Office Action Summary

09/892,790

PARK ET AL.

DETAILED ACTION

FIG. 13b

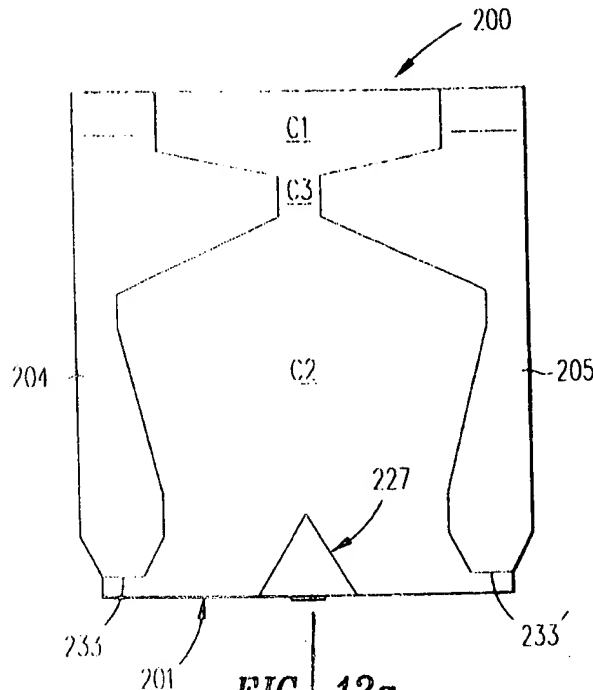
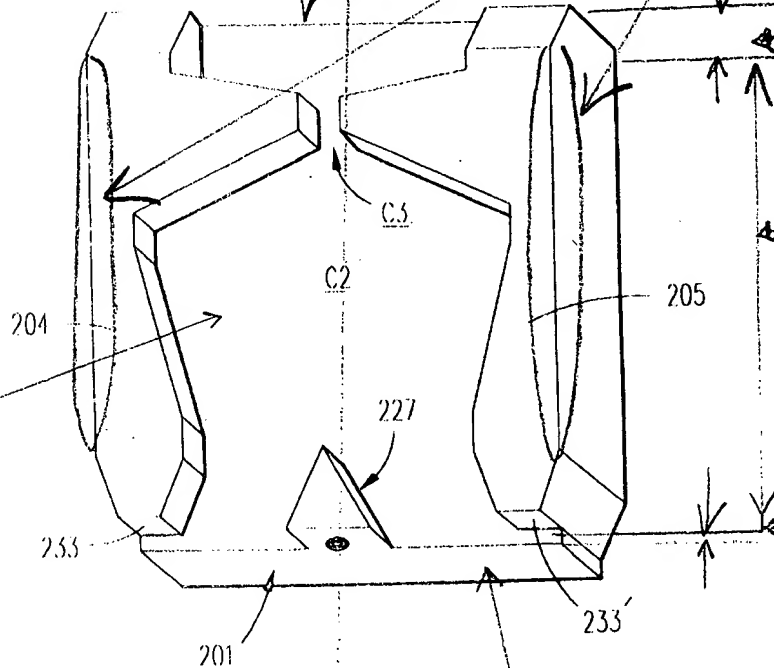
As per claim 21, Chhabra (US 5,831,791) discloses a negative pressure air bearing slider (e.g., 200 - see FIGS. 13a, 13b; see also appended Examiner's marked-up copy of FIG. 13b of Chhabra (US 5,831,791) at the end of this Office action) having a negative pressure cavity (C2),

comprising: a body with a principal surface (PS) disposed to confront a recording surface of a recording medium, said principal surface (PS) having a lead portion (LP) and a rear portion (RP), said lead portion (LP) being spaced upstream from said rear portion relative to a rotational direction (RD) of any recording medium confronted by said slider (200), said lead portion (LP) having a front edge (FE), said rear portion (RP) having a rear edge (RE), said front edge (FE) and said rear edge (RE) together defining boundaries of said principal surface (PS) transverse to said front edge (FE) and said rear edge (RE) in a longitudinal direction (LD) of said slider body (200); and a U-shaped air bearing platform (including rails (204, 205, which collectively form the U-shaped air bearing platform) circumscribing a majority of said principal surface (PS) while defining a negative pressure cavity (C2) on said principal surface (PS), said U-shaped air bearing platform (204, 205) comprising not more than two separate air bearing platforms (e.g., each rail, 204 and 205, is considered a separate air bearing platform) each extending rearwardly toward said rear portion (RP) of said principal surface (PS) and respectively terminating at a first rear termination (233) and a second rear termination (233') to form trailing terminal ends of said negative pressure cavity spaced-apart from said rear portion (RP), at least one of said not more than two separate air bearing platforms (204, 205) including a sidewall contiguous with one of said boundaries (note that both 204 and 205 form a contiguous sidewall with slider edge at boundary); at least one of said first rear termination (233) and said second rear termination (233') not coinciding with said rear edge (RE), and being disposed upstream of said rear edge (RE) relative to said rotational direction (RD) of said recording medium.

As per claims 30, 41, 51, further comprising: a rear air bearing platform (227) accommodating mounting of a transducer (see FIG. 13b), said rear air bearing platform (227) being spaced downstream of said U-shaped air bearing platform (204, 205) relative to a rotational direction (RD) of said recording medium, and being centered with respect to a longitudinal axis (LA) of said slider body (200).

(233) and the second rear termination (233'), at least one of said not more than two separate air bearing platforms (204, 205) extending from an edge of one of said boundaries (that is, 204 and 205) both extend right up to the side edge of the slider); at least one of a surface between said first rear termination (233) and said rear edge (RE) and a surface between said second rear termination (233') and said rear edge (RE) being in said first plane (i.e., the plane of the principal surface (PS) - see FIG. 13b).

As per claim 32, wherein said U-shaped air bearing platform (204, 205) further comprises: a cross rail portion (portion of (204, 205) that extend toward each other as seen I FIGS. 13a, 13b) extending generally laterally across said principal surface (PS).
